Figure 2.2-1 Trip Setpoint for Flux -- $\Delta\text{Flux}/\text{Flow}$

Figure 2.1-2 Reactor Core Safety Limit.

TABLE 3.2-1

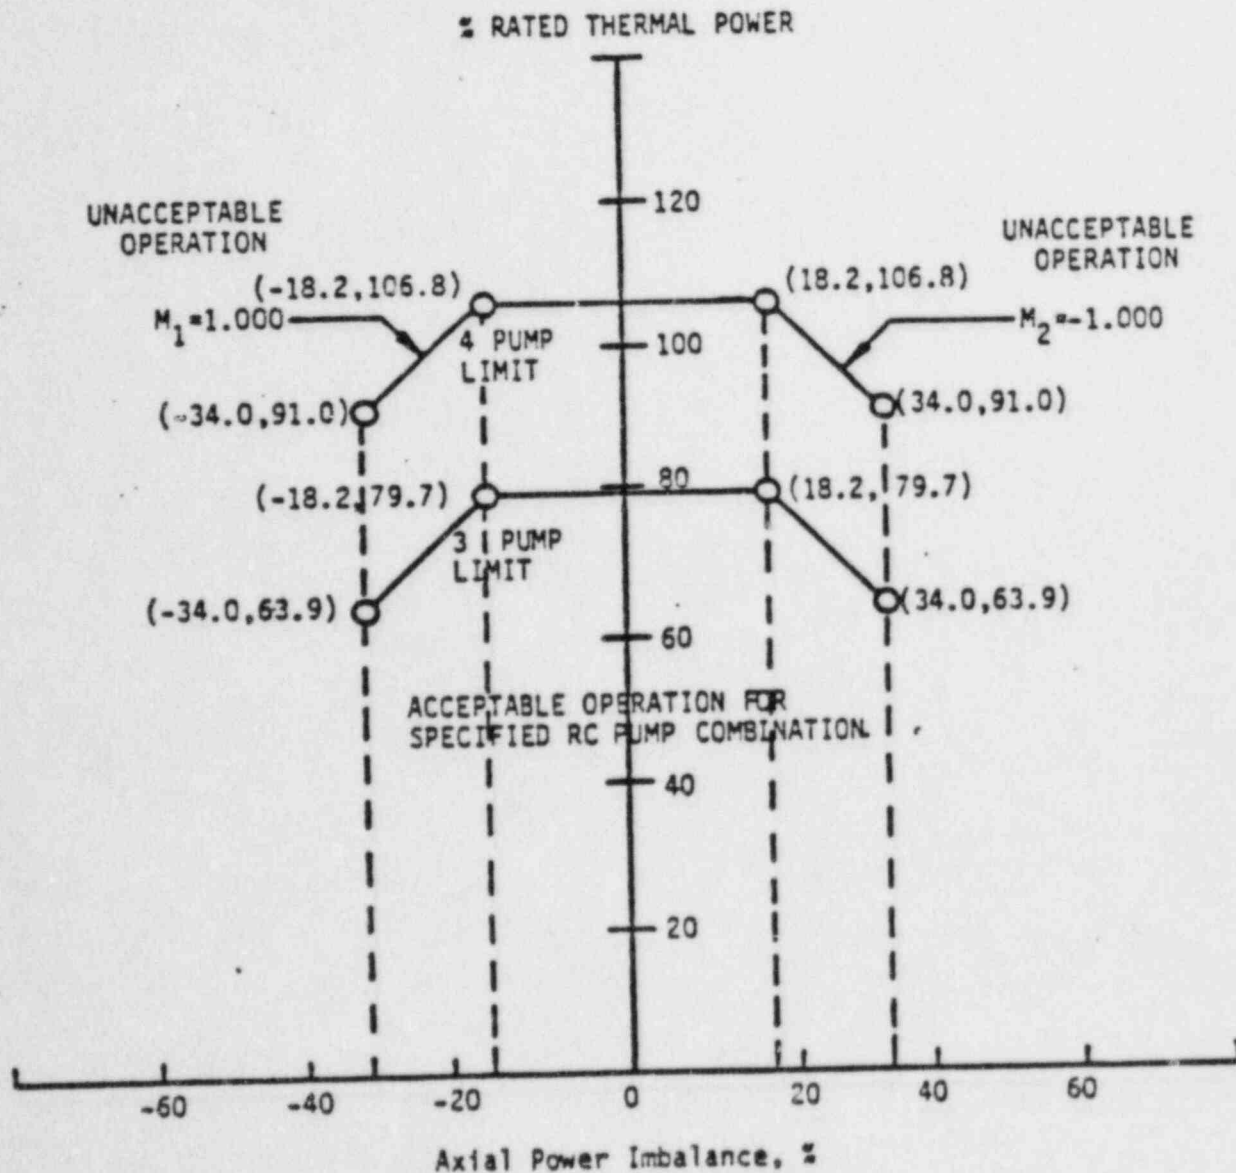
283,340

an approximately 25%

Curve shows trip setpoint for ~~25%~~ flow reduction for three pump operation (290,100 gpm). The actual setpoint will be directly proportional to the actual flow with three pumps.

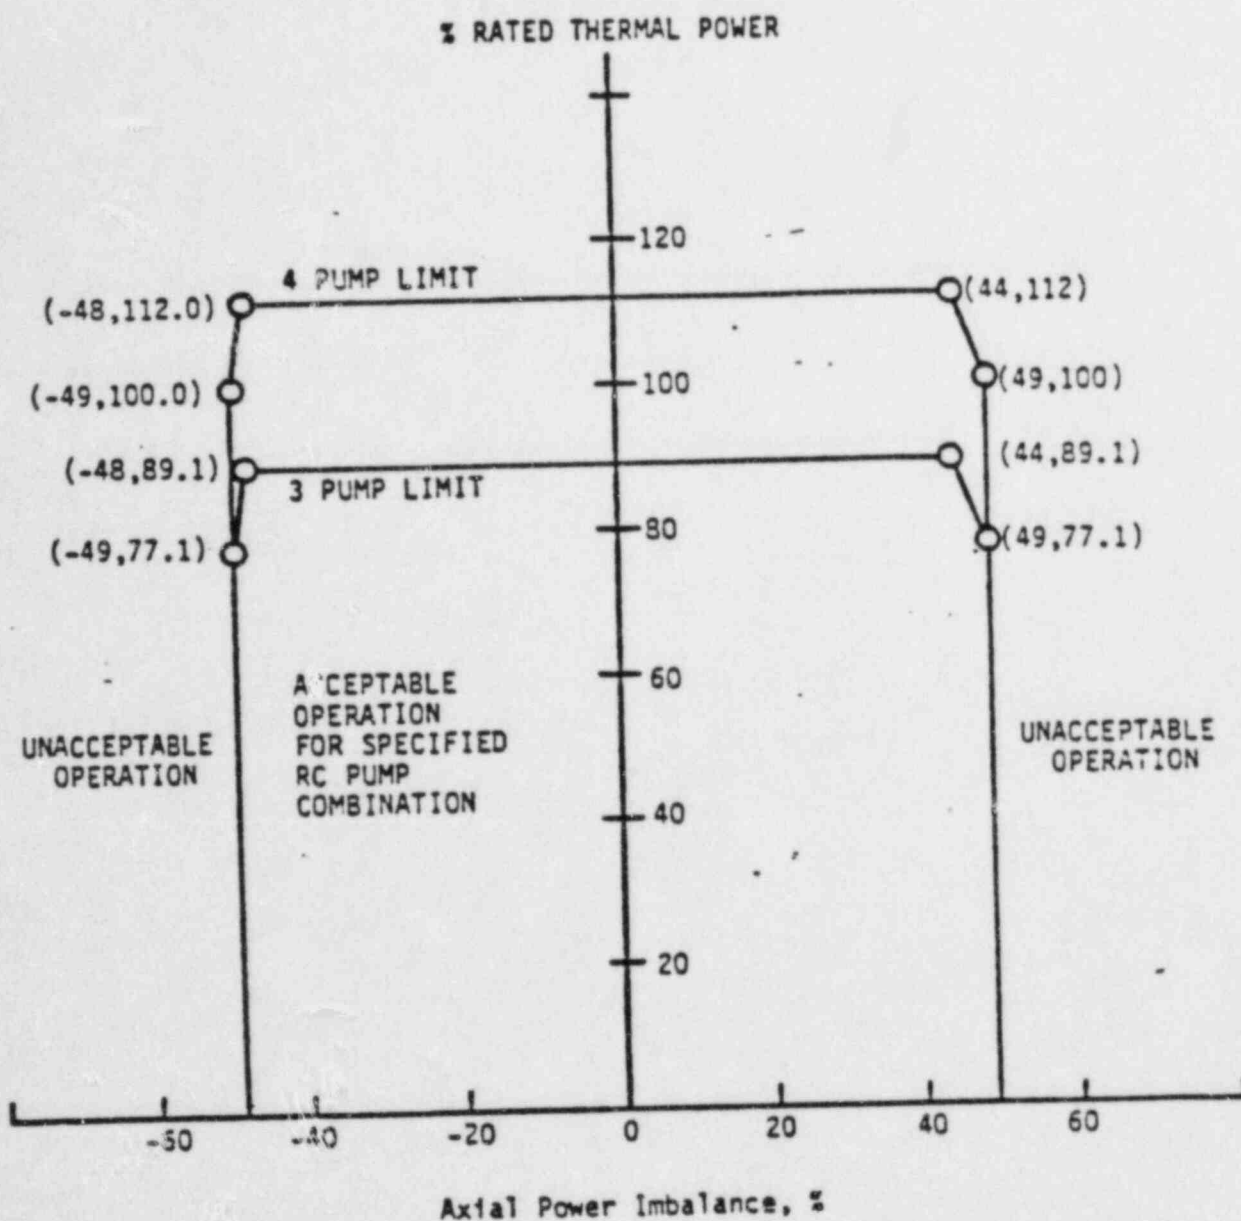
380,160 → 387,200

283,380 → 290,100

Figure 2.1 Pressure/Temperature Limits at Maximum Allowable Power for Minimum DNBR

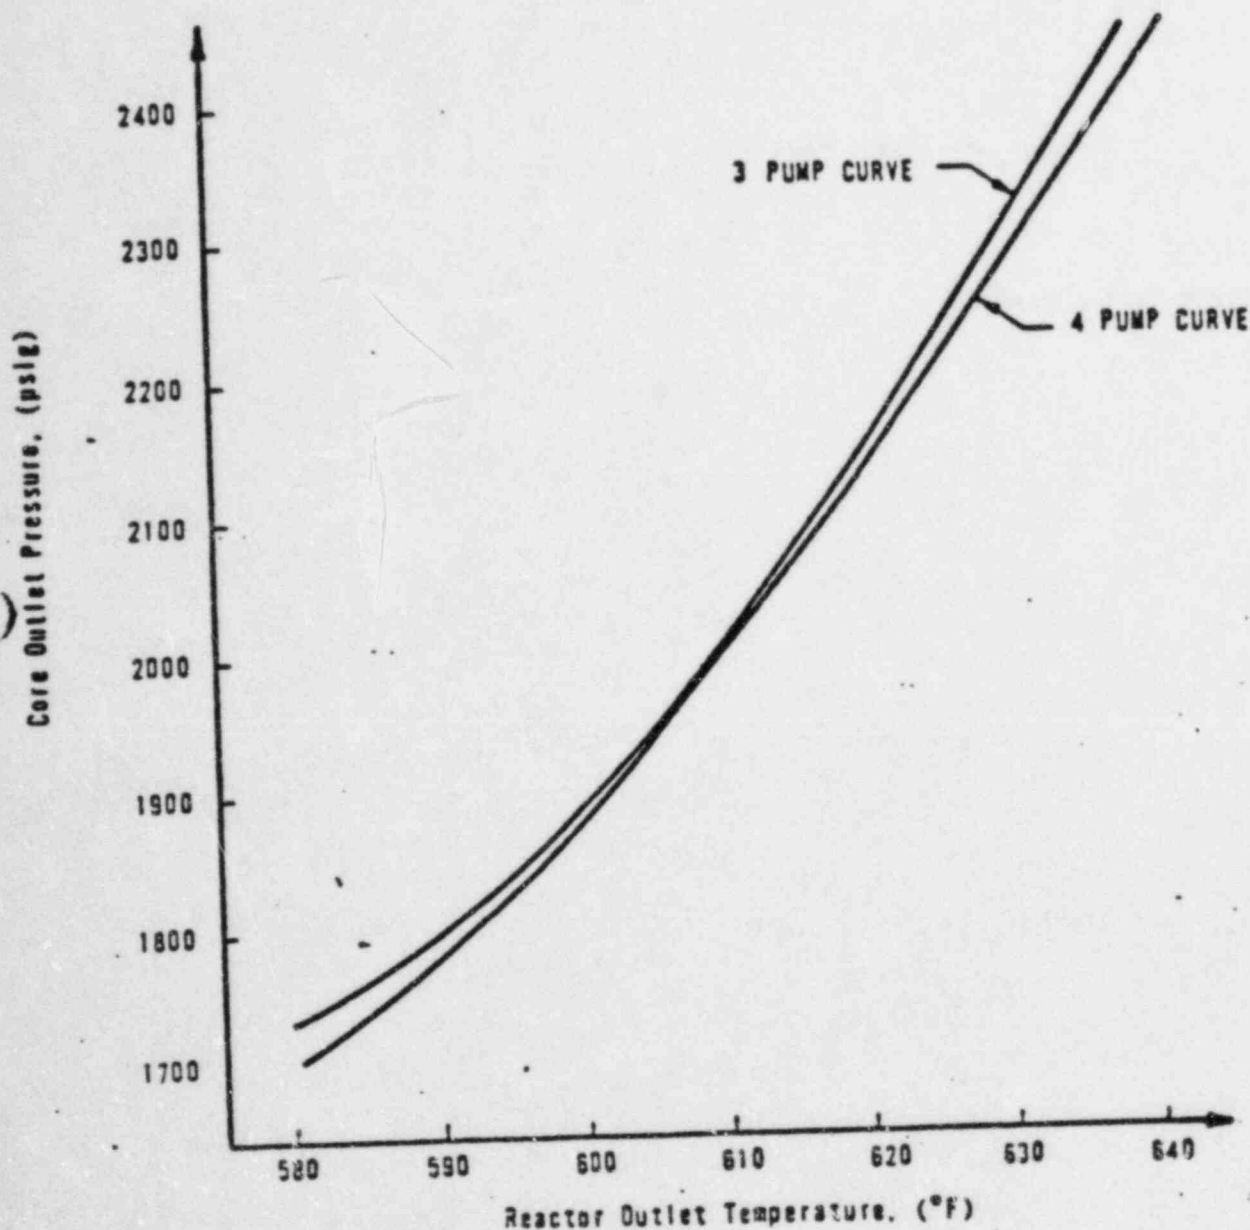
PUMPS	FLOW (GPM)	POWER
4	387,200	112%
3	290,100	88.3%
	380,160	89.1%
	283,980
